**GOVERNMENT OF THE DISTRICT OF COLUMBIA  
DEPARTMENT OF TRANSPORTATION**

**MEMORANDUM**

**SUBJECT:** ZC Case No. 17-14 – 500 Penn Street NE

**Figure 1 - Site Plan (Source: Pre-Hearing Statement)**

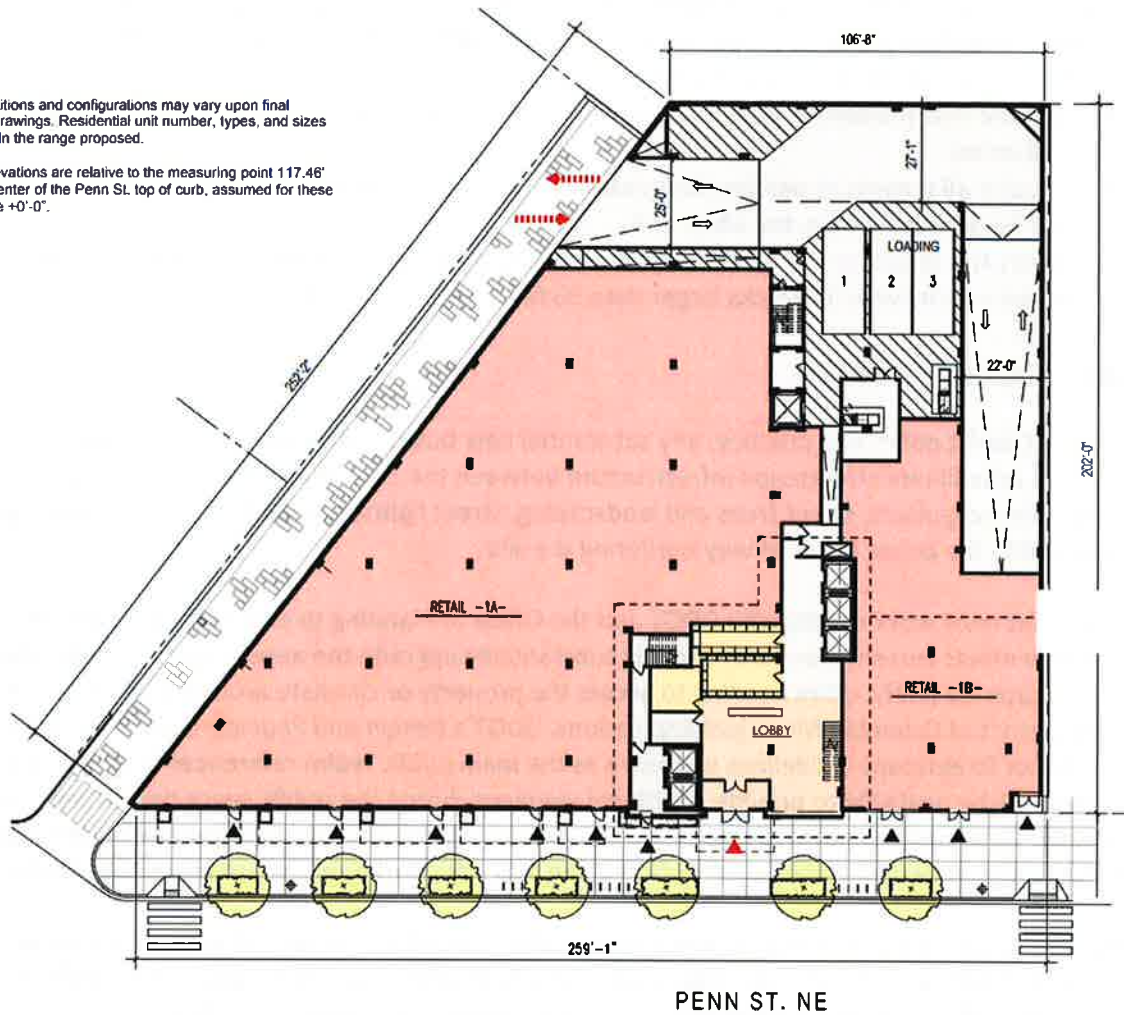
Pedestrian access is proposed from Penn Street. No pedestrian access is shown via the public alley. Figure 1 shows the proposed site plan.

Of note, the property immediately to the east of the subject site is expected to be subject to a future PUD. This neighboring property, which is under the same ownership as the subject site, does not have alley access. As discussed in the Mitigations section, providing a connection through the subject site would provide direct access from the neighboring property to the alley thus allowing site access for the neighboring property to be provided via the alley consistent with DDOT standards.

Utility vaults are shown in the public alley, which is an acceptable location for utility vaults. Grated utility vaults in public space will not be supported by DDOT during the public space permitting process.

- Special paving – Architectural plans show what appears to be circular space paving units between the main residential entrance and the curb. While some special paving may be appropriate to mark the main entrance, the amount of appropriate special paving is generally limited to twice the width of the door and projecting no further than one-third the depth of the sidewalk area.

- Public art at 5<sup>th</sup> Street & Penn Street – The Streetscape Guidelines identify this intersection as a location for public art. No art is shown in this location in the conceptual public space plans.

As noted above, the neighboring property does not have alley access and would require a curb cut to serve that site as part of a future PUD. To facilitate site access for the property to the east, the Applicant should provide an access easement on the subject site's driveway to provide direct access between the neighboring property and the alley, thus allowing site access to be accommodated consistent with DDOT standards. This connection could at a minimum serve as loading access for the neighboring property. Additional capacity analysis at the Penn Street/4<sup>th</sup> Street/alley intersection as part of the future PUD would be required to determine appropriate vehicle access.
